**STAFF RECOMMENDATION**

**307 South 11th St**

**May 20, 2020**

**Application:** New Construction - Infill

ELEVATIONS

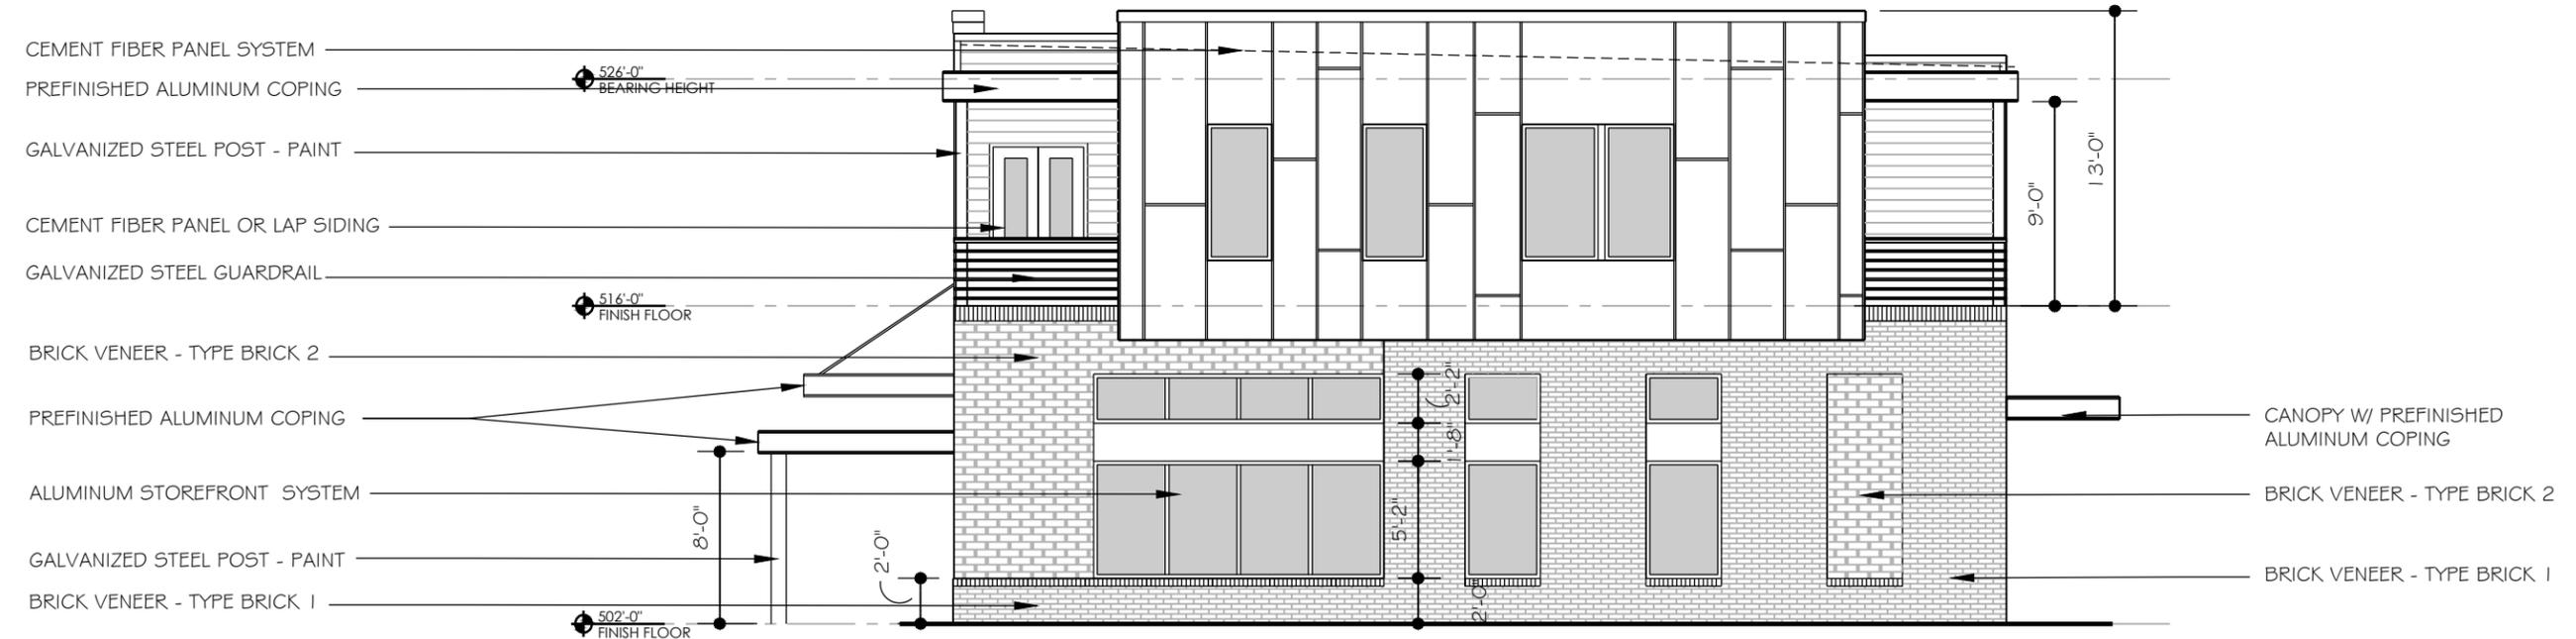
Because the building serves as a transition between the mixed-use at the corner of Fatherland S 11<sup>th</sup> to the residential district, Staff’s finds the wide width and flat roof form to be appropriate but that the building should have a massing that more appropriately makes the transition between the one-story non-historic commercial building to the left and the smaller residential buildings to the right, across and behind the proposal. The application does not meet sections II.B.1 or II.B.2.

Roof form: The roof is essentially flat behind a parapet wall, as are other historic commercial buildings to the left of this lot. To the right and behind it are pitched roofs. The project meets section II.B.5 of the design guidelines.

Proportion and Rhythm of Openings: The building's primary facade has large windows and fully glazed doors, reading like a traditional storefront. The upper-story windows have approximately a 2:1 ratio of height to width. The rear façade includes four smaller square windows; similarly, shaped windows have been approved as an accent on a secondary elevation. The longest expanse of wall space without a window or door opening is approximately eighteen feet (18') on the rear facade. Staff finds the project's proportion and rhythm of openings to meet Section II.B.7.

Staff recommends disapproval, finding that the proposed design does not fully meet Sections II.B.1 and II.B.2 for Height and Scale of the Lockeland Springs-East End Neighborhood Conservation District Design Guidelines.
